DEVELOPMENT APPLICATION ASSESSMENT REPORT

Application Number:	DA2020/1179
---------------------	-------------

Responsible Officer:	Anne-Marie Young
Land to be developed (Address):	Lot 4 DP 76695, 1795 Pittwater Road MONA VALE NSW 2103 Lot 1 DP 219265, 1797 Pittwater Road MONA VALE NSW 2103 Lot 2 DP 219265, 38 Park Street MONA VALE NSW 2103 Lot 5 DP 77493, 1793 Pittwater Road MONA VALE NSW 2103
Proposed Development:	Demolition works and construction of a Seniors Housing development with basement parking & associated landscaping
Zoning:	R2 Low Density Residential
Development Permissible:	Yes, under State Environmental Planning Policy (Housing for Seniors or People with Disabilities) 2004
Existing Use Rights:	No
Consent Authority:	Northern Beaches Council
Delegation Level:	DDP
Land and Environment Court Action:	No
Owner:	Mona Vale 3 Pty Ltd
Applicant:	Mona Vale 3 Pty Ltd

Amended ground floor (source Gartner Trovato)

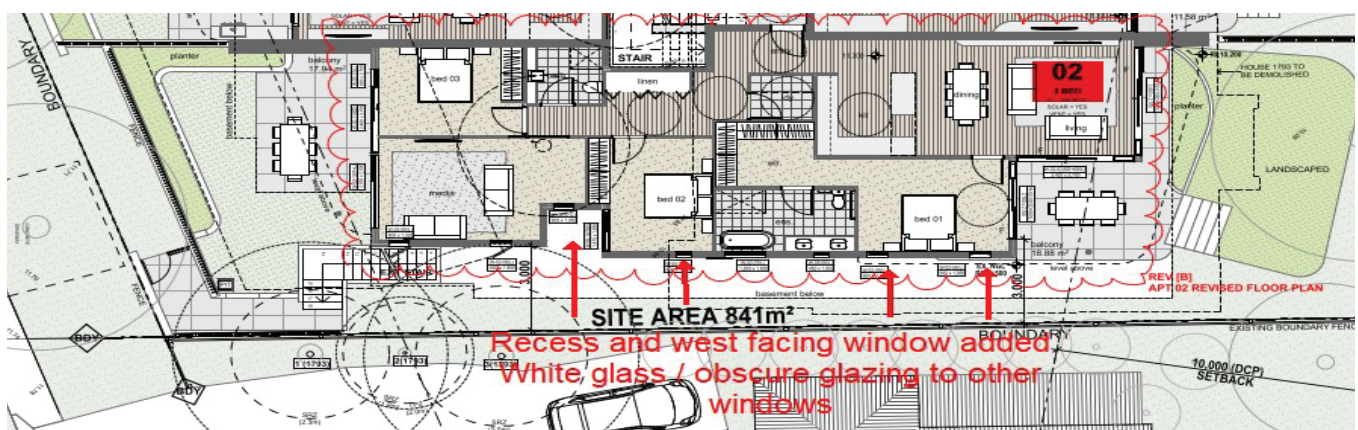
Bedroom windows to the south facing apartments No. 2 and 3 are located 3m from the southern boundary and concern has been raised by both Council's Urban Designer and the Panel regarding the potential future development potential of the adjoining property at No. 1791 Pittwater Road which is currently in use as a medical practice. In accordance with the recommendations from the Panel the apartments have been redesigned to swap the media room with bedroom 3 and provide a recesses section between the media room and bedroom 2 to allow the bedroom window to face towards Park Street and not towards the adjoining property to the south. It is noted that the current part of the adjoining site is a carpark to a medical practice, as such, the issue is therefore with the potential future redevelopment of No. 1791 Pittwater Road.

The remaining narrow louvre window to bedroom 2 shall be 'white glass' or obscure and provides amenity of cross ventilation to the bedroom whilst maintaining privacy glazing similar to the windows in bedroom 1 of the same apartment facing the same direction as accepted by the Panel, refer to plans below.

Amended ground floor (source Gartner Trovato)

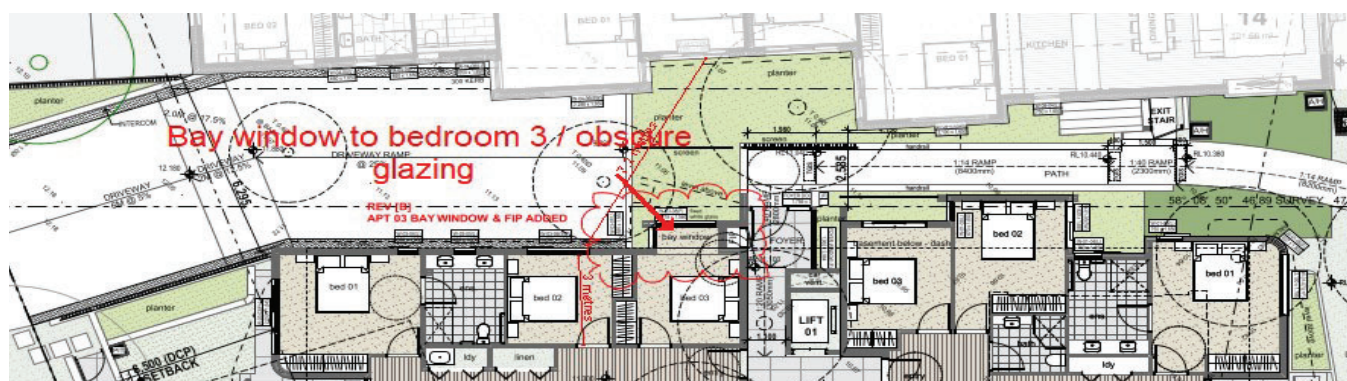
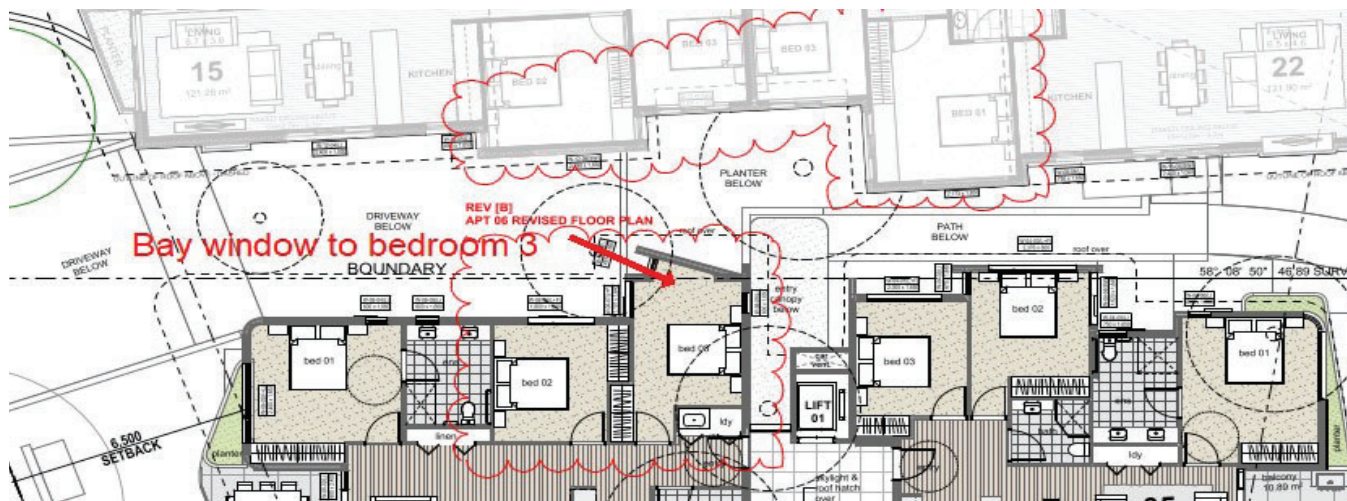
The window to bedroom 2 in apartments 3 and 6 are located 7.2m at an angle to the bedroom windows in the approved HSDP to the immediate north. The window to bedroom 3 in apartment 3 and 6 is located 6.2m directly opposite the bedroom window to the approved HSDP development. In accordance with the recommendations from the Panel the apartments have been redesigned to recess bedroom 2 apartment 3 (ground floor) and provide a bay window to bedroom 3 with a window to faces towards Park Street and white / obscure glazing in the north facing window. In addition, a privacy screen and planting help protect amenity between the proposed and approved and proposed development.

Similarly, the window to bedroom 3 in apartment 6 (first floor) has been amended to a skewed bay window which faces Park Street, refer to plans below.

In summary, the redesign of the windows provide light and ventilation to the apartments while maintaining visual and acoustic privacy to neighbouring sites in accordance with the recommendations of the Panel and Council's Urban Designer and in compliance with clause C1.5.
